November 2, 2001

Appendix B

Emergency Preparedness
Significance Determination Process

Sheet 2

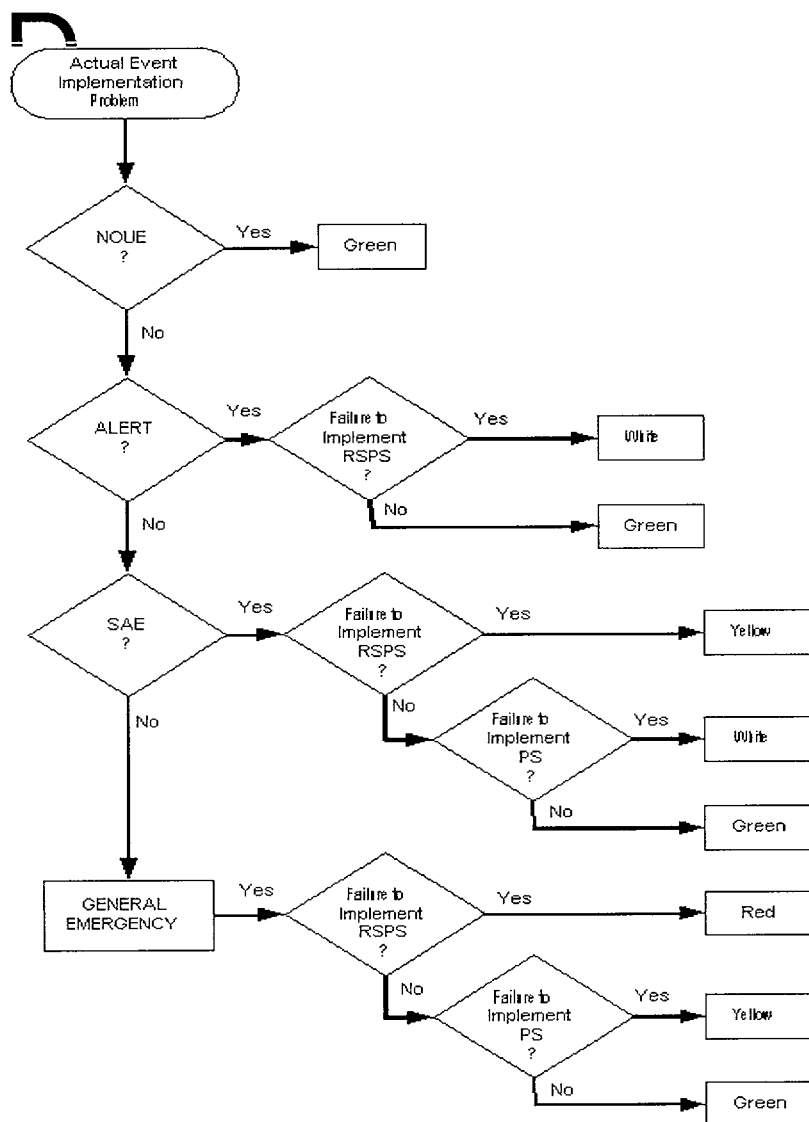
Proposed Revision to EP SDP
Failure to meet Regulatory Requirement
(This line replaces left line sheet 1 Failure to meet Regulatory Requirement)
